SUBJECT: ADMINISTRATION AND EARLY LEARNING CENTER ADDITIONS
ORCHARD FARM R-V SCHOOL DISTRICT
ST. CHARLES, MISSOURI
PROJECT # 23-09C

ORCHARD FARM R-V SCHOOL DISTRICT
ADMINISTRATION AND OFFICE ADDITIONS
ST. CHARLES, MISSOURI

JULY 23, 2024

The drawings and specifications are hereby supplemented and amended to include the following particulars:

M3.1
SD:1

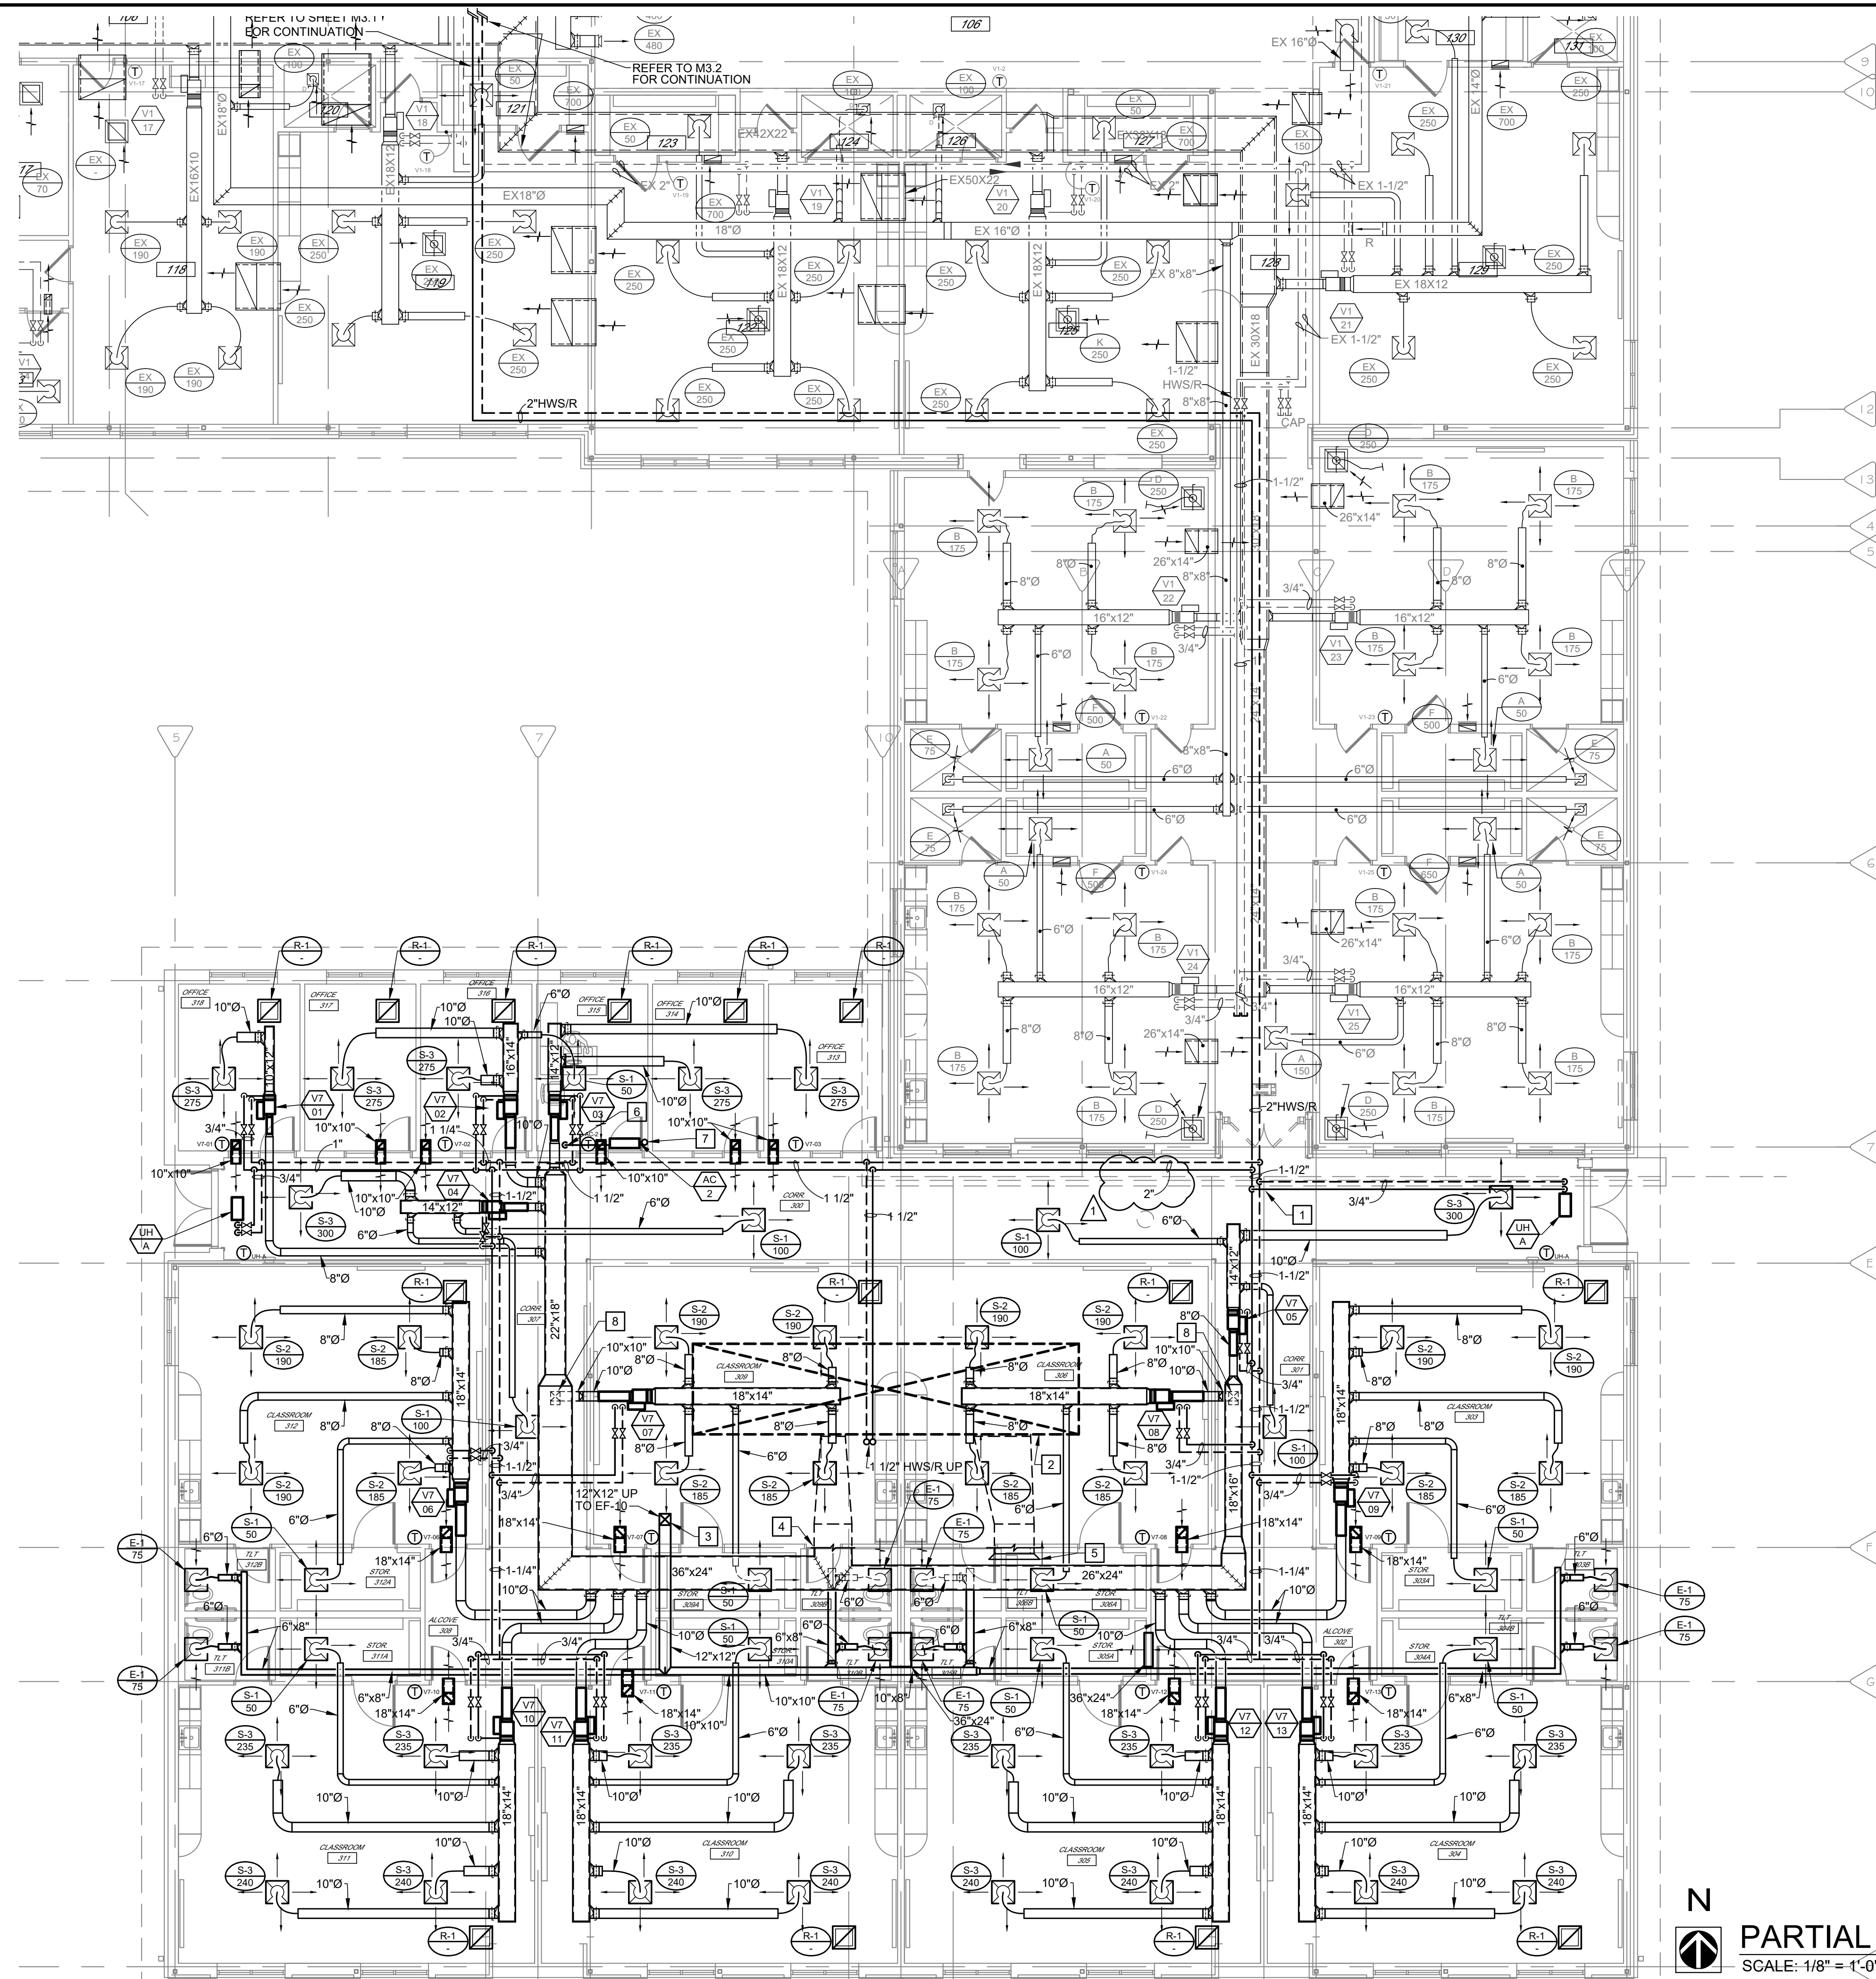
ITEM NO. 4 – MECHANICAL DRAWING SHEET M3.1 (SD-1)

- A. **“REVISE”** Heating water pipe sizing.

M6.2
 SD:2

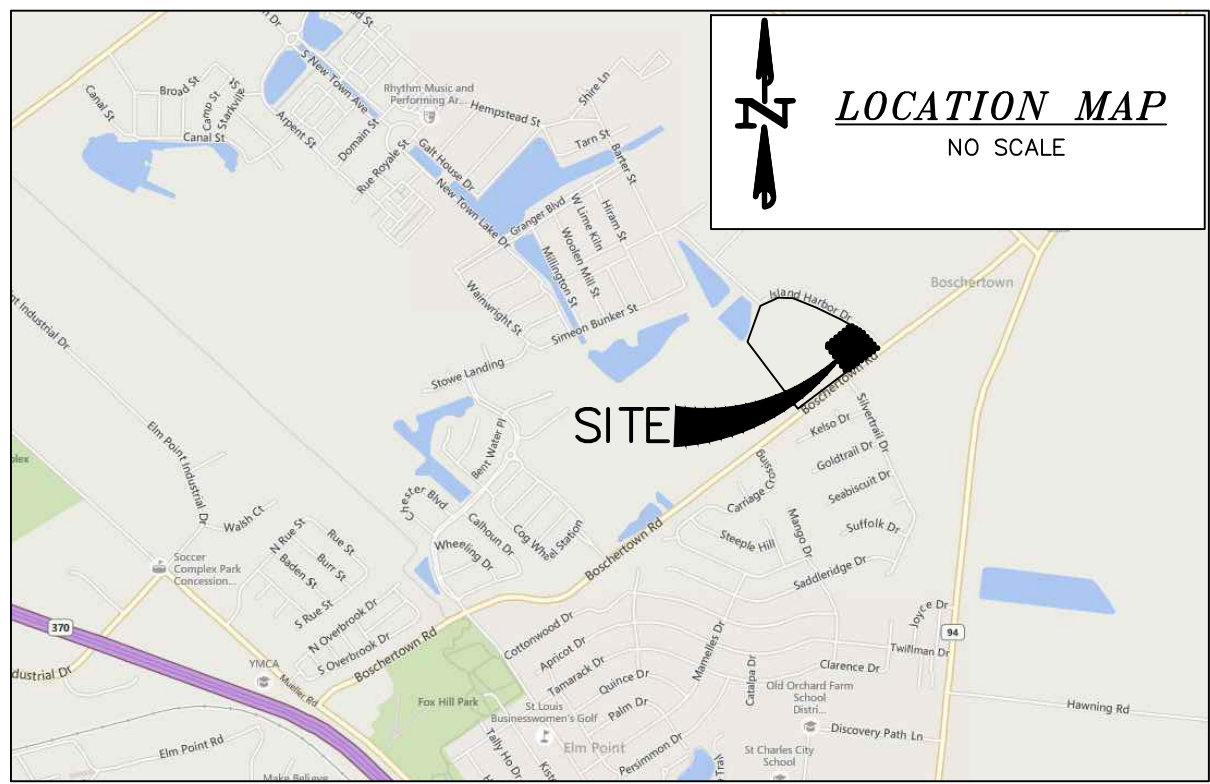
ITEM NO. 5 – MECHANICAL DRAWING SHEET M6.2 (SD-2)

- A. **“ADD”** Notes 13 & 14 to Packaged Rooftop Unit Schedule.
- B. **“REVISE”** Note 3 and Model No. for CV-RTU7

C1.00
SD-3

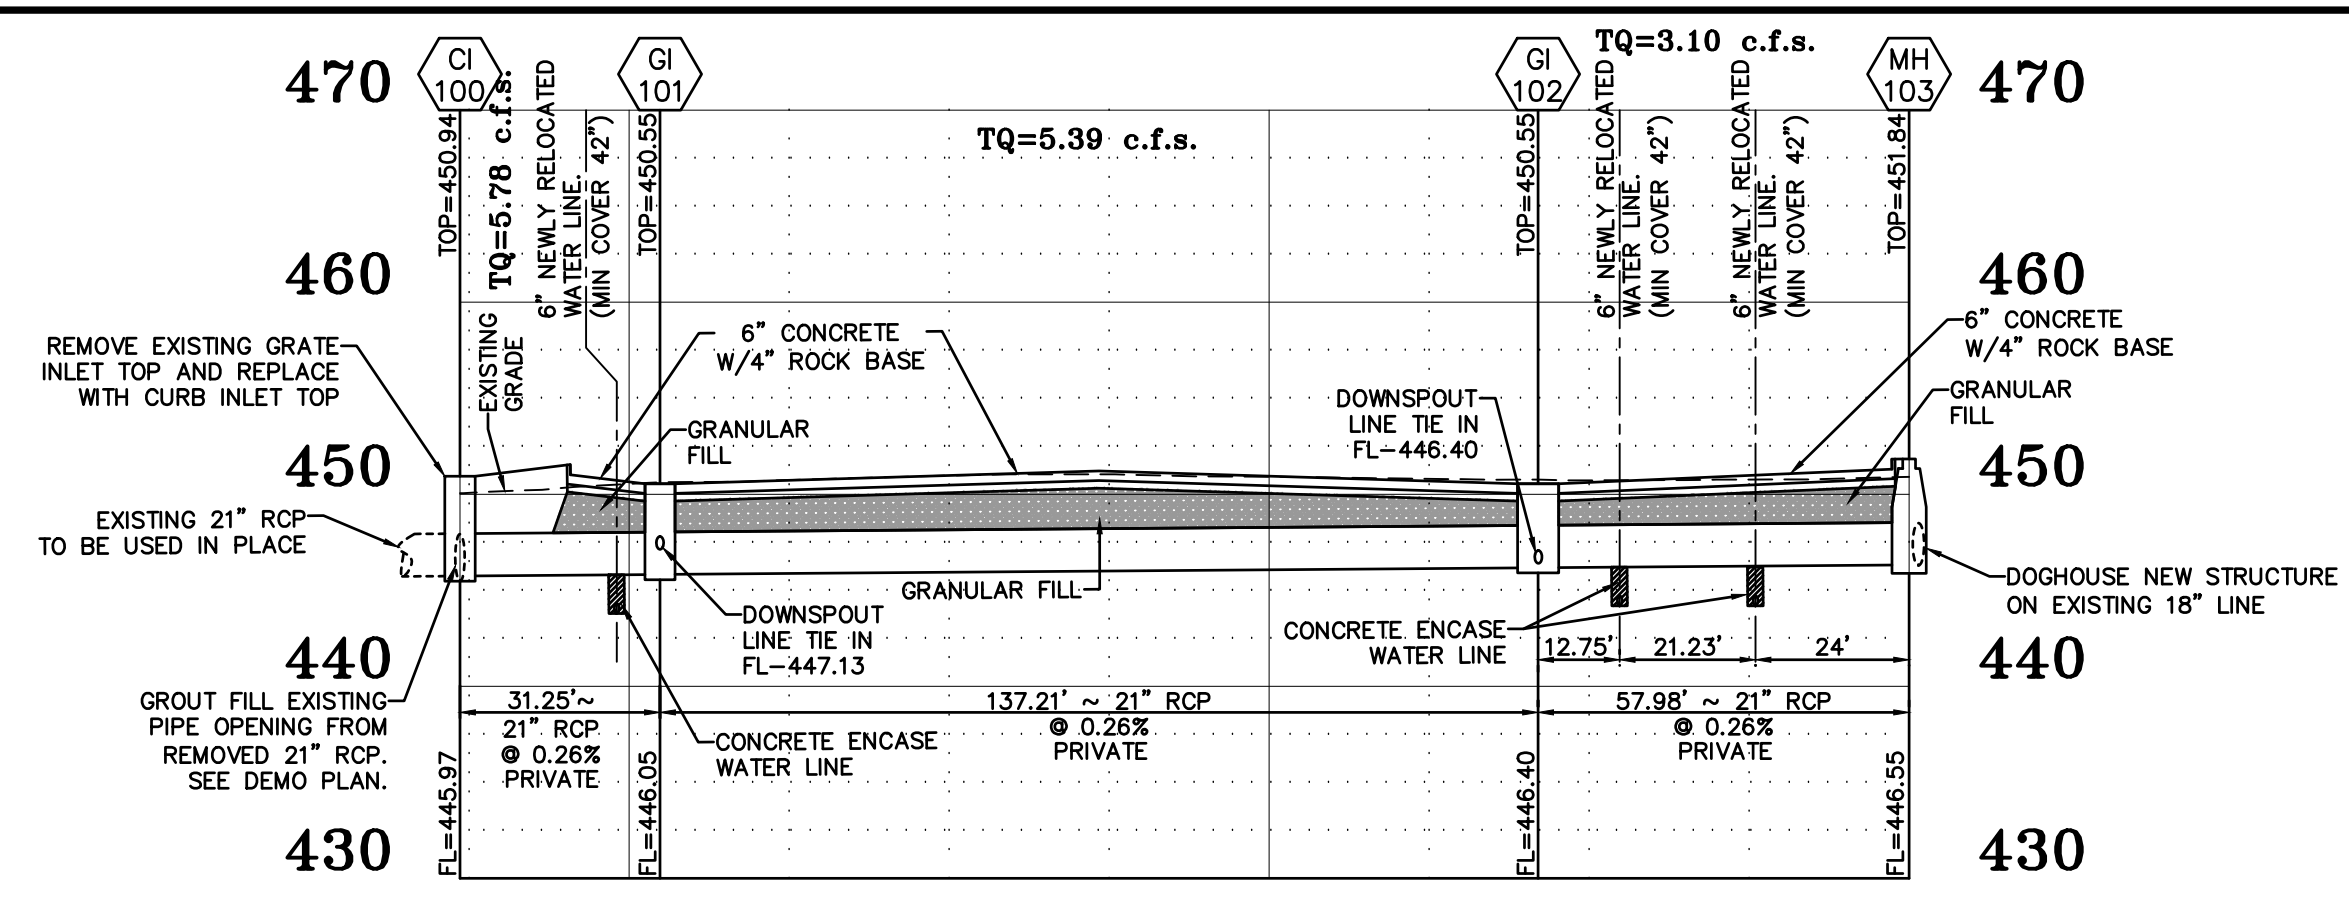
ITEM NO. 2: CIVIL DRAWING C1.00

- A. **“ADD”** Supplementary Drawing No. SD 3, dated July 23, 2024 included with this Addendum, and hereby made a part of the Contract Documents that shows revised grading quantity and added general note 9 for pavement remediation included in base bid.

GRADING QUANTITIES:
5,000 C.Y. CUT (INCLUDES SUBGRADES)
1,513 C.Y. FILL (INCLUDES 8% SHRINKAGE)
3,487 C.Y. HEAVY

- BASE BID TO INCLUDE PAVEMENT REMEDIATION UNDER ALL DRIVEWAYS. REMEDIATION SHALL EXTEND ONE FOOT OUTSIDE DRIVEWAY EDGES. SEE DETAIL ON SHEET C7.00.
